9 REVIEW OF THE FEASIBILITY STUDY ON THE EASTERN MISSING LINK OF THE EAST-WEST HIGHWAY

9.1 Introduction

9.2 Summary Results of the Review

Figure 9.5.1 Proposed Typical Cross-section between An Phu and RR2

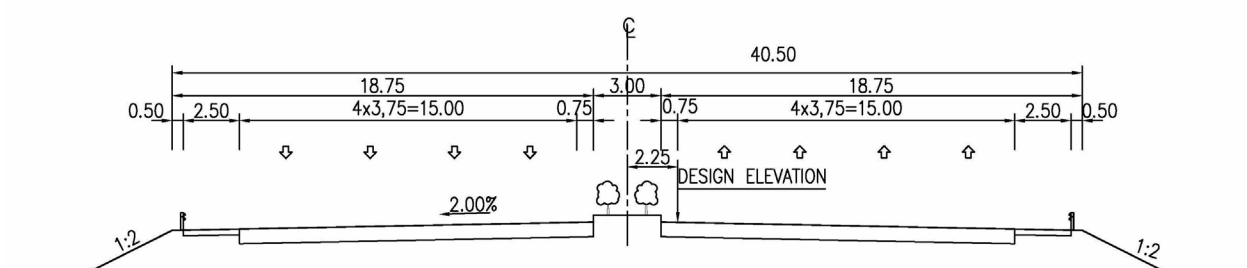
In terms of traffic demand, it is proposed to build dual 3-lane, total 6-lane, expressway for the throughway between An Phu Interchange and RR2 Interchange in Phase 1. However, the distance of the throughway is 3.3km only, and it is two (2) minutes to pass the section when the travelling speed is 100km/hr.

Considering An Phu Interchange and RR2 Interchange are developed for 8-lane throughway interchanges, it is strongly recommended to develop this 3.3 km section as dual 4-lane, total 8-lane road in Phase 1.

Figure 9.5.3 Interchange Layout (Modified Double Trumpet Type) in Previous Stage for RR2 Interchange

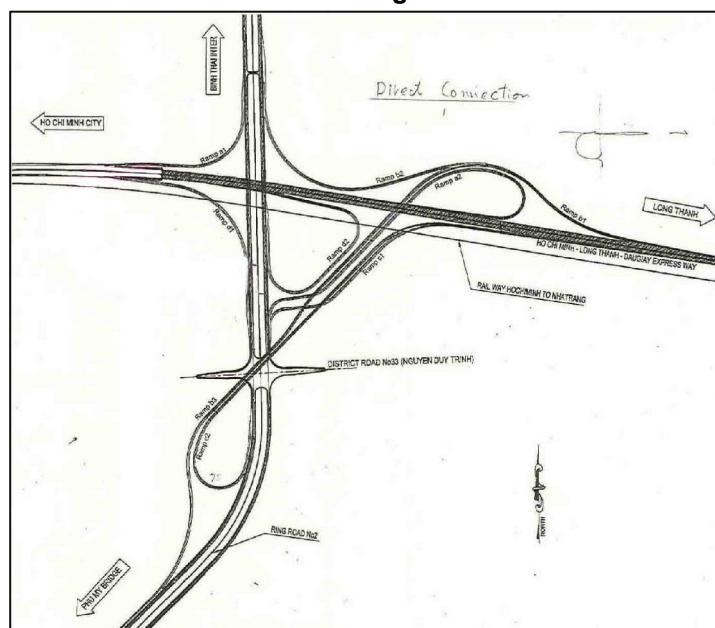
- (d) **Review of Previous Studies:** There are some real-estate developments at the neighbouring areas; it might be strict design constraint for the interchange planning. In the previous studies, interchange layout avoiding the land development was prepared as shown in Figure 9.5.3.

It is proposed that “Standard Double Trumpet Type” has very much advantage, not only for the construction cost in short time but also VOC¹ and VTT² saving for long term, if some land is available for the construction works.

Figure 9.5.5 Proposed Interchange Type at RR2

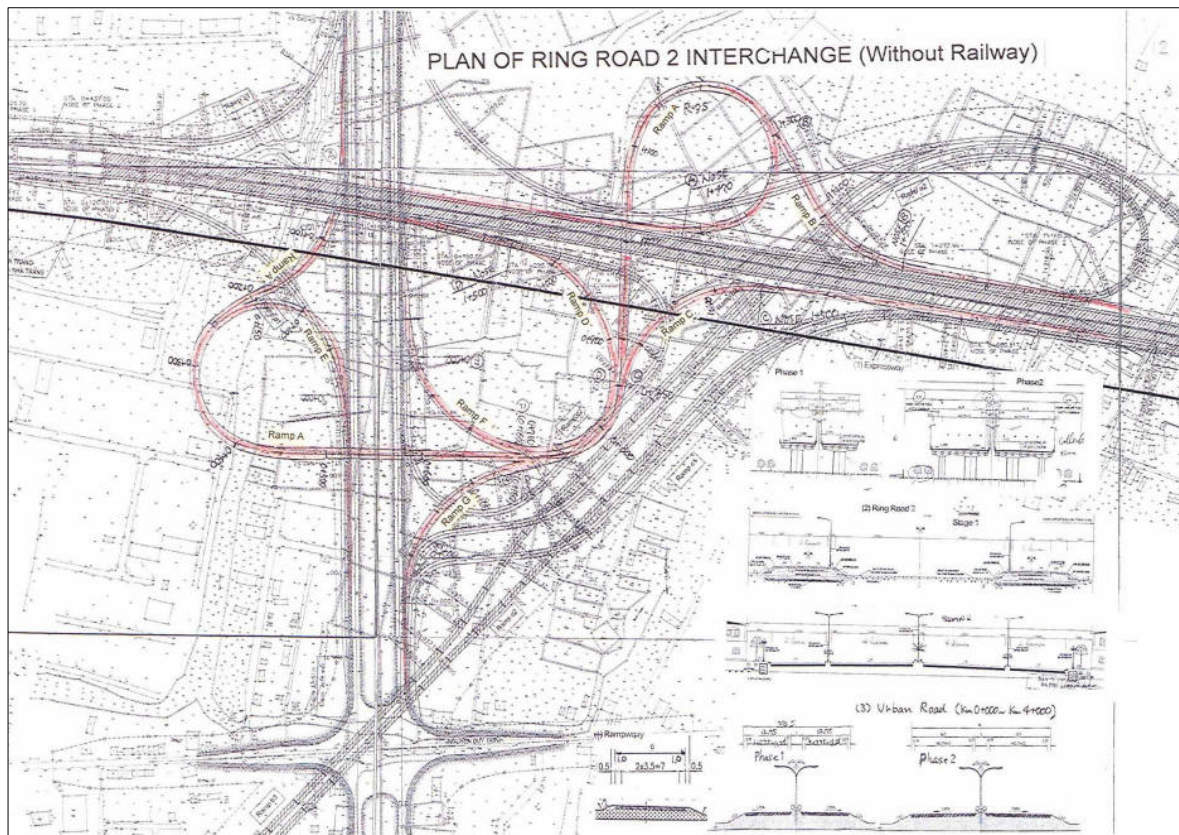
- (g) **Selected Intersection Type at RR2 Intersection:** If land developer could accept the DT-1 layout, this is the most recommendable. Availability of the land should be confirmed before selection of the interchange type.
